TB 1-1520-240-20-154

DEPARTMENT OF THE ARMY TECHNICAL BULLETIN

MANDATORY MAINTENANCE ON TRANSIENT AND AVOID BANDS ON THE CRUISE GUIDE INDICATOR ON ALL CH-47D AIRCRAFT

Headquarters, Department of the Army, Washington, D. C.
3 May 2004

FIGURE 1

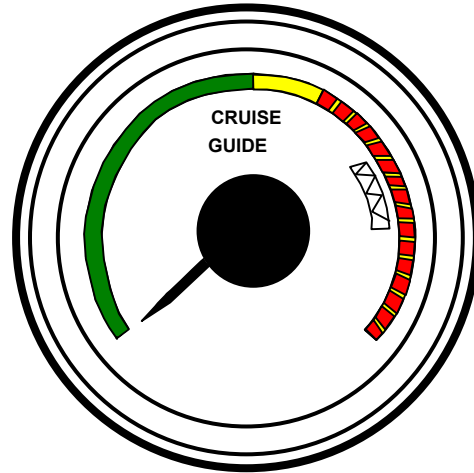
- (1) Utilizing Figure 1, cut out the “re-marked” Cruise Guide Indicator template.
- (2) Cut out the red/yellow striped (avoid) band from the Figure 1 “re-marked” CGI template.

- (3) Center the “re-marked” template on the aircraft CGI (P/N 152BUA34-2 or 114VS805-3).
- (4) Tape the outside edges of the “re-marked” template to the CGI.

- (5) Apply red instrument marking tape to the CGI display glass at the location where the red/yellow striped band was removed from the Figure 1 template. If instrument tape is unavailable then a piece of red tape placed on the glass at the beginning of the new red/yellow striped region denoted by the “re-marked” template is sufficient.

Measuring with a protractor placed in the center of the gauge, the red band of the new avoid region begins at 63 degrees above horizontal. The red band arc length of the new avoid region is 1 7/16". The new yellow band arc is 5/16" long.

The yellow band on the re-marked CGI represents 100% to 120% rotor control/drive system design load. The red (avoid) band on the re-marked CGI begins at 120%.

(a) Change Figures 2-14-1 and 5-2-1 to reflect the same length red/yellow striped arc as in figure 1 "Remarkd" gage. Measuring with a protractor placed in the center of the gauge, the red band of the new avoid region begins at 63 degrees above horizontal. The red band arc length of the new avoid region is 1 7/16". The new yellow band arc is 5/16" long.

....Insure that the diameter of the diagram matches the
diameter of the gauge. The inner diameter of the bands is 1.4".
Measuring with a protractor placed in the center of the
gauge, the red band of the new avoid region begins at 63
degrees above horizontal. The Red Band Arc length of the
new avoid region is 1 7/16". The new Yellow Band Arc is
5/16" long.
